# Access Compliance Report

## Public Rights-of-Way

Intersection ID: 20476	Main Street: SHADOWCREST_DR	Cross Street: WOODKNOLL_DR	Location: W
ADA ID: 0EFA08E440B6	Ramp Type: Perp	Initial Pass/Fail: Fail	Overall Compliance: No
Codes/Mitigation Info/Possible Solution		Field Measurements/Component Compliance	
Severity Score: 48.75

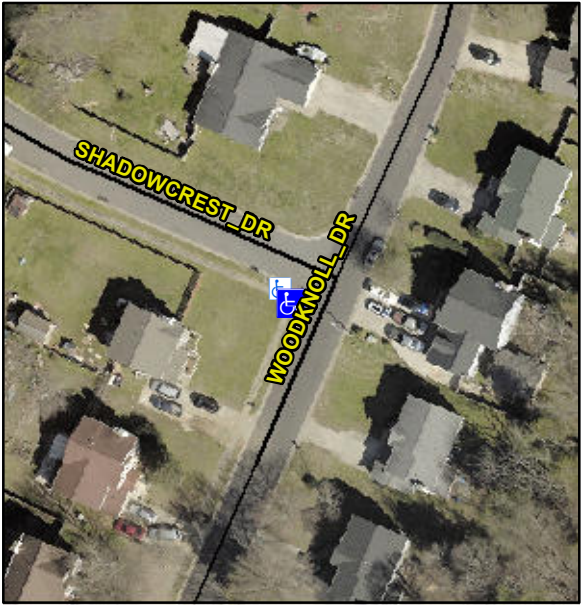
Possible Solutions:	Compliance	Description	Data	Compliance	Description	Data
	Remove & Replace Entire Ramp.	N/A	Ramp Length (in)	91.0	No	Ramp Slope (%)	9.8
		No	Ramp Width (in)	25.0	No	Ramp XSlope (%)	4.0
		N/A	Flare Type LT	N/A	N/A	Flare Type RT	N/A
		N/A	Flare Slope LT (%)	N/A	N/A	Flare Slope RT (%)	N/A
		N/A	Flare Traversable LT?	N/A	N/A	Flare Traversable RT?	N/A
		N/A	Landing Length (in)	N/A	N/A	DWS Provided?	N/A
		N/A	Landing Width (in)	N/A	N/A	DWS Contrast?	N/A
		N/A	Landing Slope (%)	N/A	N/A	DWS Length (in)	N/A
		N/A	Landing X Slope (%)	N/A	N/A	DWS Full Width?	N/A
<p>Surveyor Notes:</p> <p>N/A</p> <p>PROW/ADA:</p> <p>R304.5.1, R304.2.2, R304.5.3</p>		N/A	Landing Curb? (Y/N)	N/A	N/A	DWS Offset (in)	N/A
		N/A	Shared Landing?	N/A			
		N/A	Gutter Ponding?	N/A	N/A	Gutter Slope (%)	N/A
		N/A	Gutter Lip Ht (in)	N/A	N/A	Gutter X Slope (%)	N/A
		N/A	Painted X Walk1?	No	N/A	Painted X Walk2?	N/A
			X Walk 1 Direction	To SE		X Walk 2 Direction	N/A

N/A	X Walk 1 Width (in)	N/A	N/A	X Walk 2 Width (in)	N/A
			X Walk 1 Slope (%)	3.1		X Walk 2 Slope (%)	N/A
			X Walk 1 X Slope (%)	1.0		X Walk 2 X Slope (%)	N/A
		N/A	Ramp inside XWalk1?	N/A	N/A	Ramp inside XWalk2?	N/A
<p>Street 1 Name</p> <p>Stop Condition-Street 2</p> <p>Street 2 Name</p> <p>Stop Condition-Street 1</p>			Road Slope (%)	N/A	N/A	Clear Space?	N/A
			Road X Slope (%)	N/A	N/A	Clear Space to XWalk (in)	N/A
		N/A	Any Obstructions?	N/A	N/A	Storm Grate/Utility Hazard?	N/A
			Obstruction Type			Storm Grate/Utility Type	
					N/A		N/A
					Yes	Surface Condition? (G/P)	Good
Total Cost:		\$	1850.00
